[NOTICE] Terminal Plating Change

Engineering Change Notice of Pure-Sn plating for QFP

Package : QFP

SEIKO EPSON Corporation
Micro Devices Operation Div.

Solder ability1 Steam aging	Solder ability2 High temp storage
Photo after solder dipping

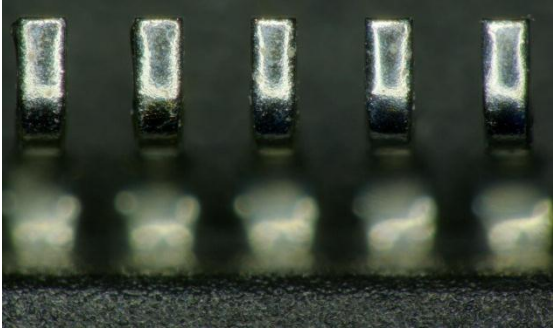
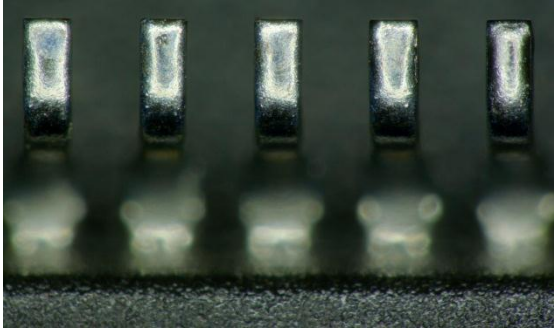
■ Solder ability1

Steam aging : 4hrs
Flux dipping time : 5~10sec
Solder temp. : 245°C
Solder dipping time : 5sec

■ Solder ability2

High temp. storage : 150°C 16hrs
Flux dipping time : 5~10sec
Solder temp. : 245°C
Solder dipping time : 5sec

Solder wet rate more than 95%

Pass. All terminal solder wets rate more than 95%

<Representative photo after 1000 cycle >

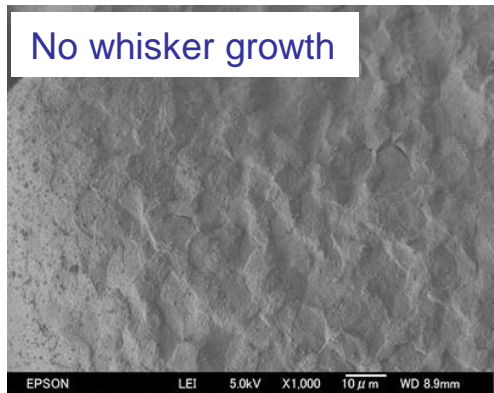
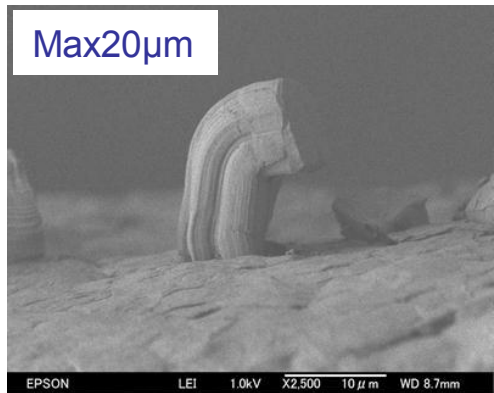
- Sample : P-LQFP048-0707-0.50(QFP12-48Pin) N=10
- Board spec.
 - Dimension : 100mm × 100mm t = 1.6mm
 - Material : FR-4
 - Layer count : 1 layer(One side board)
 - Cu layer : 35μm
 - Surface processing : Water-soluble pre-flux processing
- Solder paste : Sn-3.0Ag-0.5Cu
- Test condition : -40°C ⇔ 125°C (each 30 minute)
- Judgment criteria : A conduction part being left in the section part by section observation
- Test result : Pass. Because a conduction part is left in the section part after 1000cycle
